SUBJECT: Ink Cartridge "O" Ring and Rubber Pad

FROM: Copier Technical Support Section

MODEL:

VT2100/2130/2150

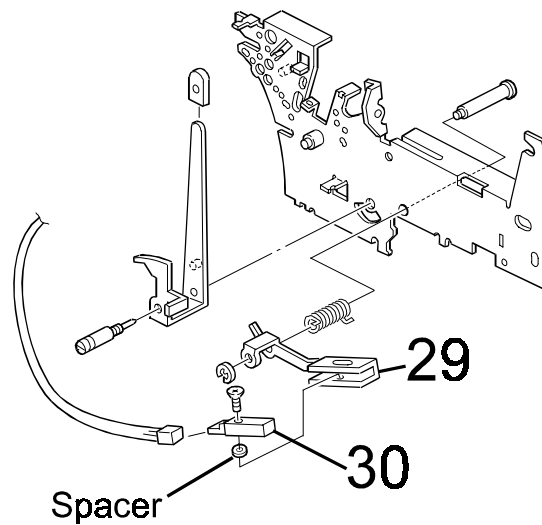
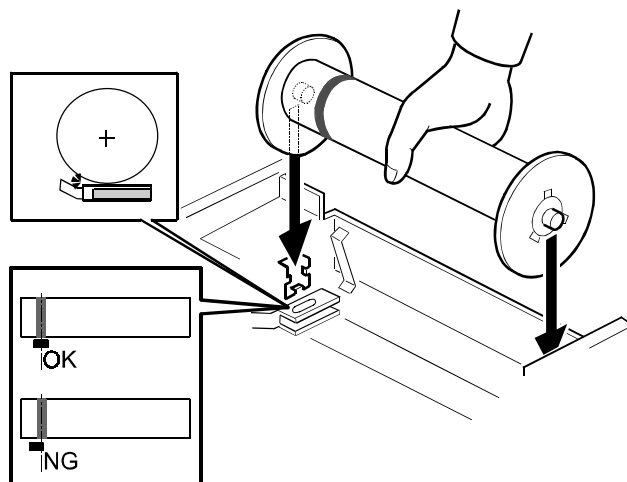
The machine continues to rotate the Master Roll even after the actual end condition is reached, stripping the roll paper off the roll. The very edge of the roll paper with the adhesive then causes a jam when it sticks to the Master Feed Rollers.

The Master End Sensor does not detect the black end stripe on the roll due to performance variations.

Change the sensor, or adjust the sensor's position as shown on the next page.
An output check for the Master End Sensor has been added from July 2001 production.

1. Unplug the power cord and slide the Scanner Unit to the left as seen from the operation panel side.
2. Lift the release lever and remove the Master Roll.
3. Raise the sensor position by installing a 0.2 mm-thick spacer as shown above (08072071). If this spacer has no effect, install one more 0.2 mm spacer or remove the first one and use a 0.4 mm spacer (07010030Z).
